SERVICE BULLETIN No. 001SP-32-001

LANDING GEAR – NOSE WHEEL STEERING – STEERING DISCONNECT PANEL

INTRODUCTION OF SELF-LOCKING NUT ATTACHING PARTS FOR TOGGLE LATCH AND TOGGLE LATCH STRIKE (AMENDMENT C)

FIGURE 1 - Amendment Label - Location

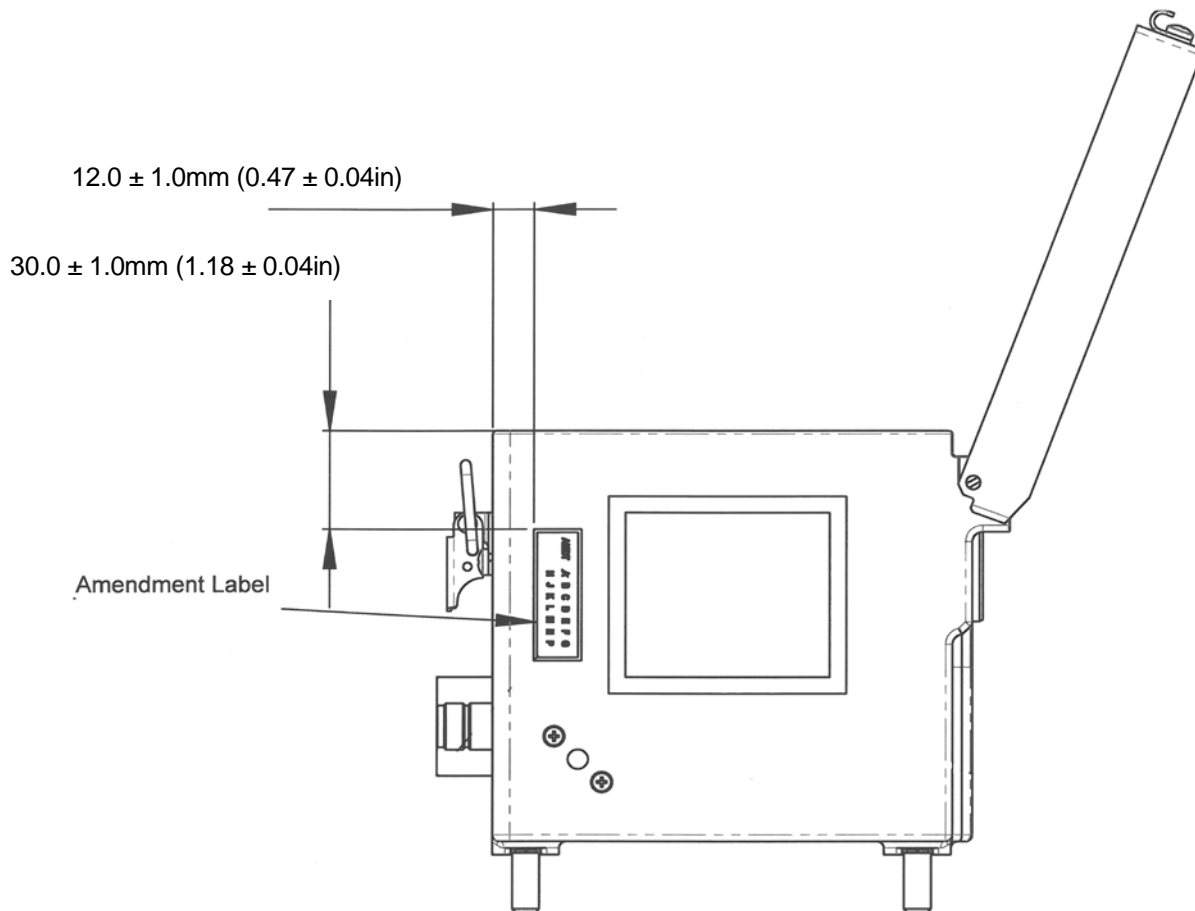
- (1) If the Steering Disconnect Panel is fitted with an Amendment Label go to Para. 3.D.6.
- (2) If the fitment of an Amendment Label is required, carry out the following instructions.
- (3) Refer to Figure 1 and locally clean the area with IPA and allow to dry. Make sure the area is clean and free of grease.
- (4) Remove protective backing from the new Amendment Label and place in position as shown in Figure 1.

- (5) Apply even pressure across the Amendment Label to make sure the Label is secure.
- (6) Strike through Label "C" to indelibly identify the Steering Disconnect Panel as Amendment C.
